**BUILDING SITE ADDRESS:** 1728 W. 4th St., #1728, Westchester Ave, SACRAMENTO, CA 95811

**NATURE OF WORK IN DETAIL:** Construction of Single Family Dwelling

**TRUSS REPAIR DETAIL**

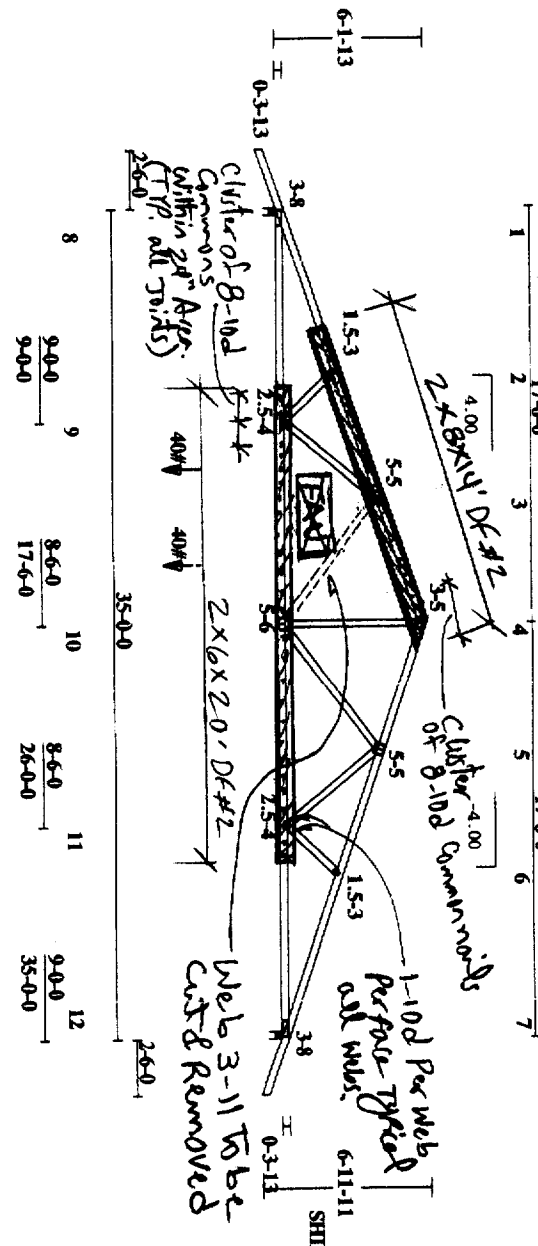
**Condition:** Web # 3-10 to be cut and removed to allow access for the FAU in attic.

**Repair:** Scab both faces of top and bottom chords where shown with 2x's per the size and length as noted (or longer), using 10d common nails at 6" O.C. staggered through out. Add cluster of 8-10d within the 12" distance to each joint and 1-10d into each web. Then cut web 3-11 back as needed
